Tender No. EM/28/2011

Name of work – (1) Internal and External Electrical Work for 400 seated Multi Training Facility Building at this Institute.
(2) HVAC system work

Sub:-Minutes of the Pre-Bid Meeting held on 21.09.2011 at IITM Pune		
Name of The Work:-Internal & External Electrical work for Multi Training Facility Building at IITM, Pashan, Pune.		
Pre -Bid Date:-21.09.2011		
Tender Ref No:-EM/28/2011		
Sr No	Questions from Bidders	Clarifications
1	Reference Tender Document Page No.3 Cost of Tender Document/Tender Fee	Rs.1000/- as DD should be submit along with technical bid if downloaded from Web site, else refer Institute receipt No. for Rs.1000/- paid by cash for tender document. DD from nationalized or scheduled bank should be drawn in favour of Director,Indian Institute of Tropical Meteorology,Dr.Homi Bhabha Road,Pashan,Pune-411008
2	Reference Tender Document Page No. 3 & 8 EMD & DD whoes favour we have to prepare/drawn ?	EMD for amount of Rs 110000/-(Rupees One lacs & Ten Thousand Only) should be submit along with technical bid in the form of DD/BG from nationalized bank or scheduled bank in favour of Director,Indian Institute of Tropical Meteorology,Dr.Homi Bhabha Road,P

DRAWING TITLE	STREET LIGHTING, LA & EARTHING LAYOUT FOR SITE
PROJECT	INTERNAL & EXTERNAL ELECTRICAL WORK OF MULTI TRAINING FACILITY BUILDING, PASHAN, PUNE
CLIENT	IITM PUNE

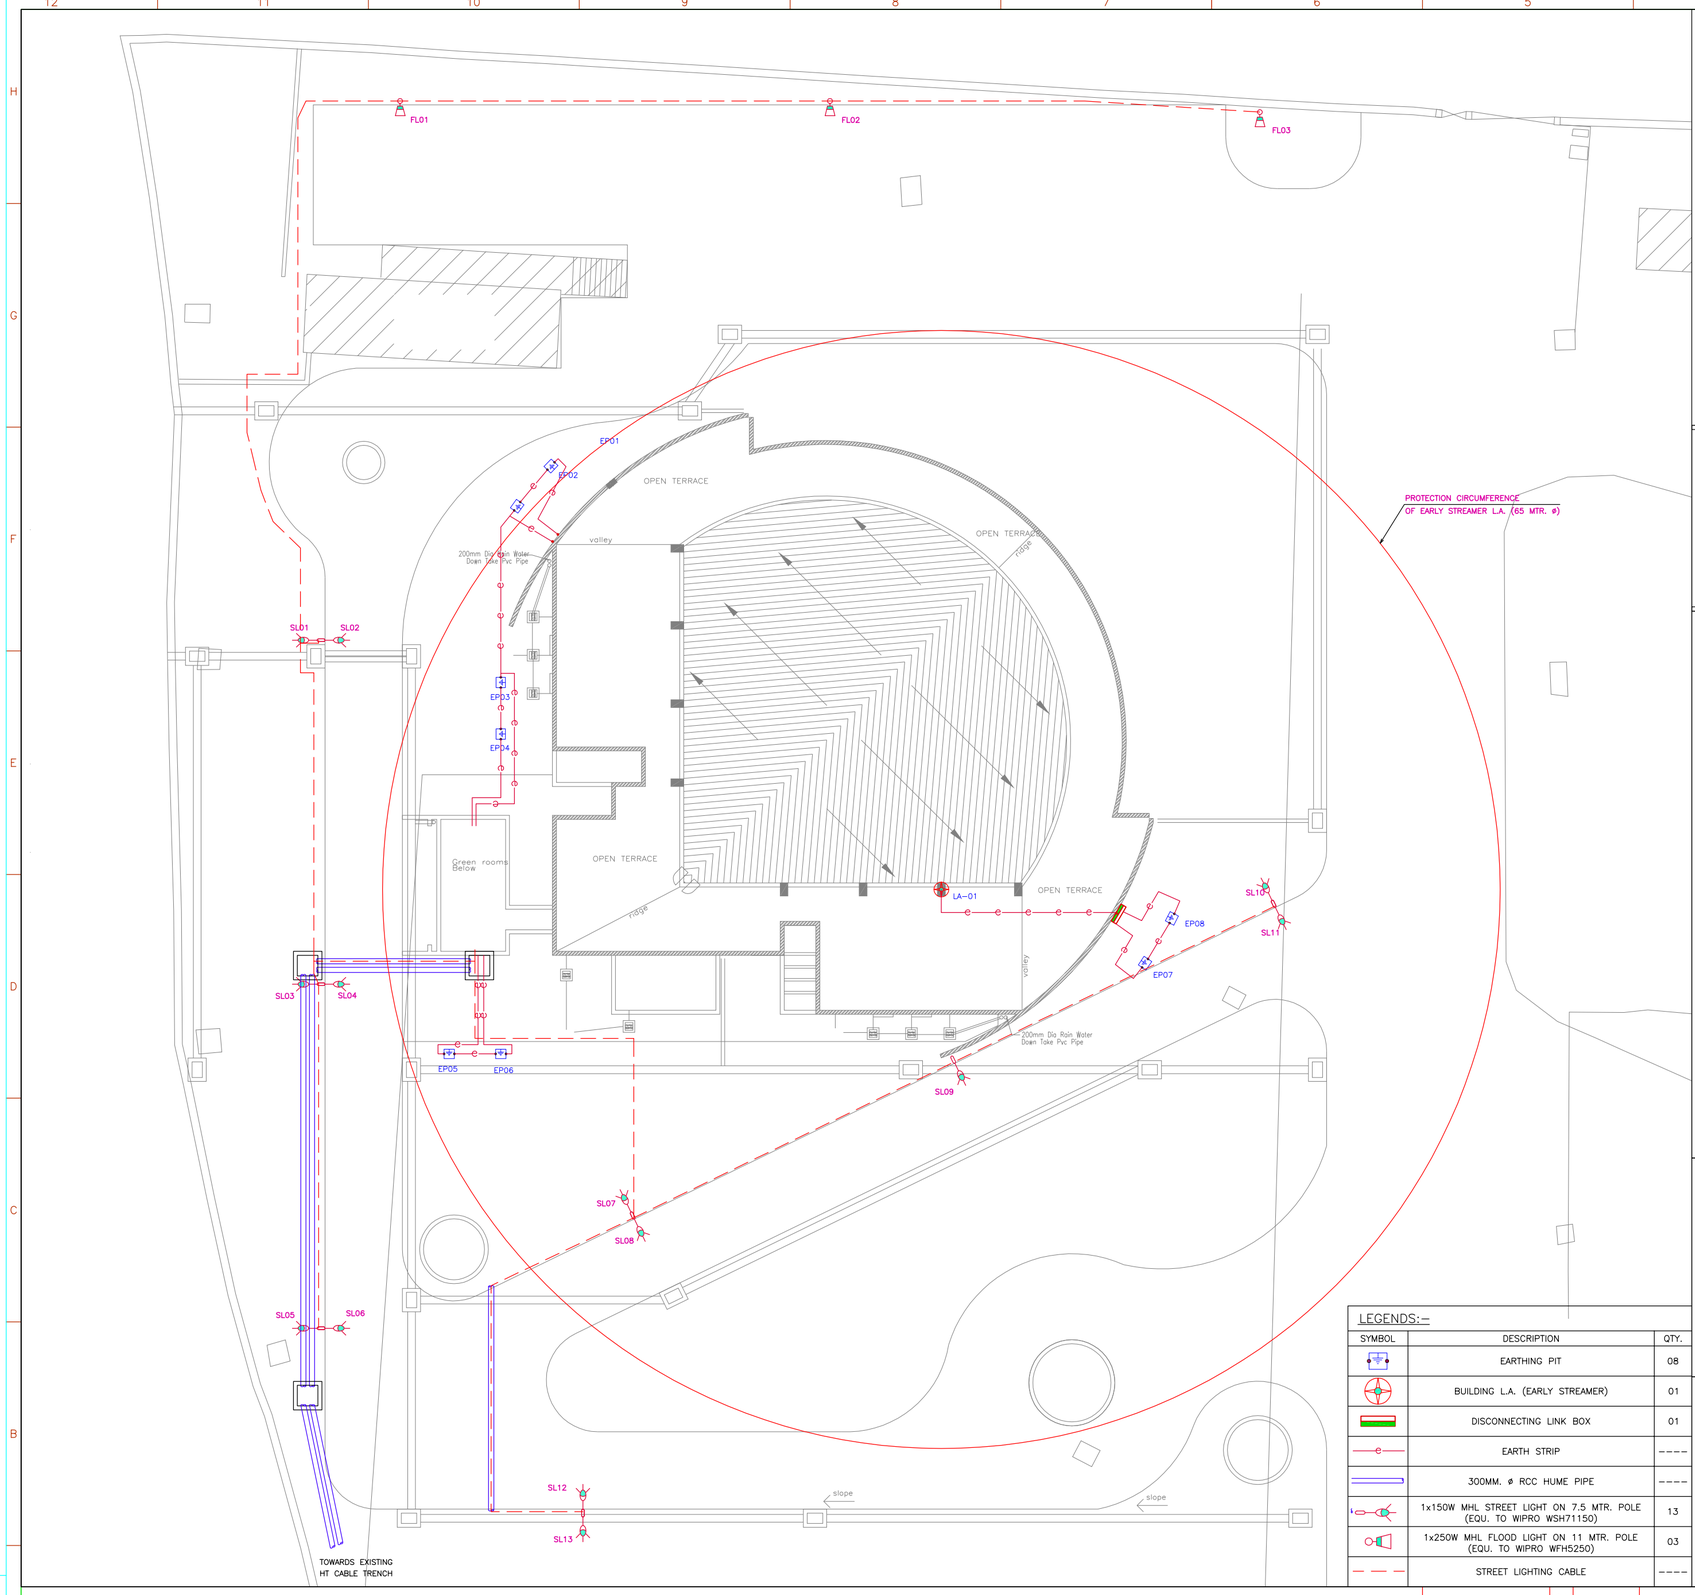
Item no 1.1 & 1.2:-There is specified to provide 6mtr & 12 mtr Pole.Please specified type of street light pole-sewage/octagonal?	
22	Reference Tender Document BOQ Page no.7 Section VI(External Lighting)	with reference to item no 1.4 i.e. WFH 52250 Flood light 1x250W,this not LED type flood light,consider Standard 1200mm bracket for mounting

Item no 1.2 :-There is specified to provide 12 Mtr Pole with 1200 mm long suitable bracket for mounting LED street light, please provide Installation details / drawing for fixing of 1X250 W WFH 52250 light fitting (Item No. 1.4 Section - VI)

Item no. 7.3 There is specified to provide RJ-11 cable,Kindly specified two pair with 0.5 mm dia. Or any other as required?	
21	Reference Tender Document BOQ Page no.7 Section VI(External Lighting)	For item no 1.1 refer Sr No.17 & for item no 1.2 consider octagonal street light pole
